RE: OCOONEE NUCLEAR STATION, UNITS NOS. 1, 2 AND 3

Enclosure:
Interim SER on Effects of
Fuel Rod Bowing on Thermal
Margin Calculations for
Light Water Reactors

INTERIM SAFETY EVALUATION REPORT
ON EFFECTS OF FUEL ROD BOWING
ON THERMAL MARGIN CALCULATIONS
FOR LIGHT WATER REACTORS

FIGURE 2.1

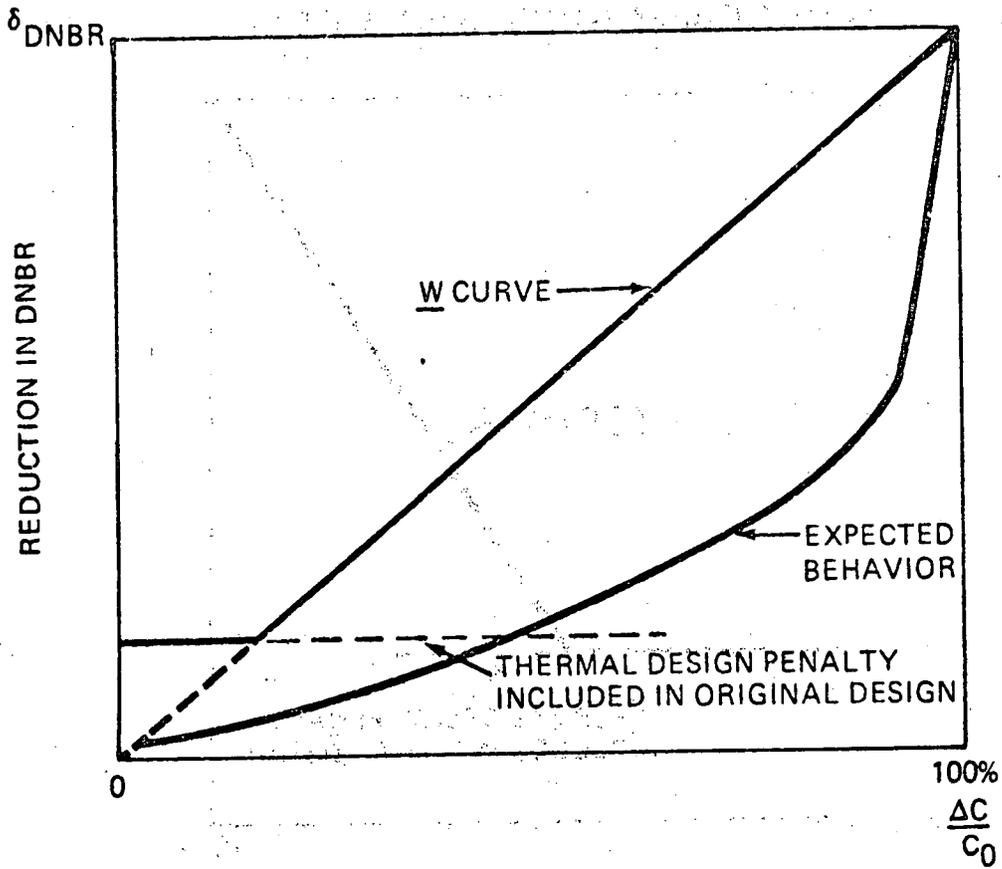
As stated in Section 2.1, data were presented by Westinghouse for the DNBR reduction at full contact and with no bow. No data at partial gap closure were presented. Westinghouse proposed, and the staff accepted, a straight line interpolation between these two points as shown in Figure 2.1.

This approach is conservative if the DNBR reduction does not increase more rapidly than the straight line reduction shown in Figure 2.1. Although the data for DNBR reduction due to rod bowing in the presence of an unheated fuel rod cannot be predicted by existing analytical methods, one would nevertheless expect that the actual behavior would more nearly follow the curved line also shown in Figure 2.1. According to this curved line, the DNBR would be reduced gradually for small amounts of bow. As the fuel rods (or fuel rod and unheated rod) become close enough so that there is an interaction, the DNBR would decrease more rapidly. No physical mechanism has been postulated which would lead to sudden large decreases in the DNBR for small or moderate gap closures. Thus, the straight line approximation is believed to be an overestimate of the expected behavior.

In developing the interim rod bow penalties described in this report, it became apparent that the penalty should be a function of burnup since the magnitude of rod bow is a function of burnup. However, to maintain existing thermal margins early in core life when only a small amount of fuel rod bow is anticipated, the initial pitch reduction factor was included until such time as the rod bow DNBR reduction became greater. This is represented as the straight horizontal line on Figure 2.1.

FIGURE 2.2

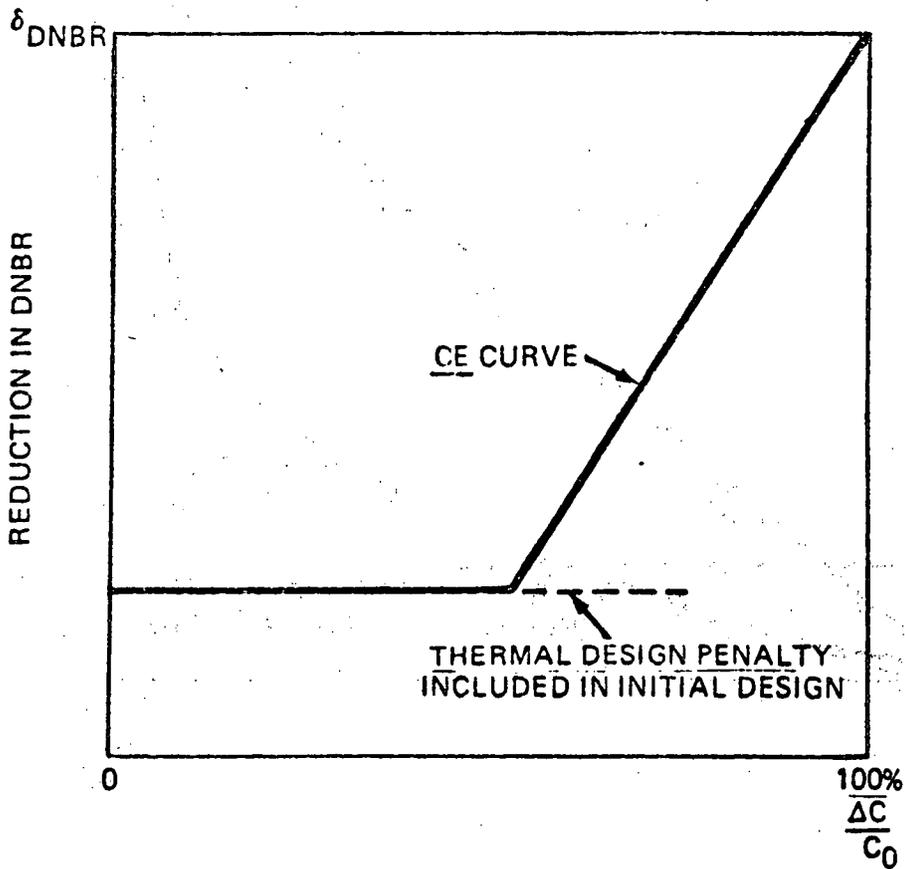
Combustion Engineering performed experiments to determine the effect of rod bowing on DNBR which included some cases in which the effect of partial bowing as well as bowing to contact was determined. Again, a straight line interpolation is used. However, the point of zero DNBR reduction is not at zero clearance reduction but rather, at an intermediate value of clearance reduction. This is shown schematically

in Figure 2.2. The horizontal straight line, representing the initial pitch reduction factor is included as explained previously in Section 2.2
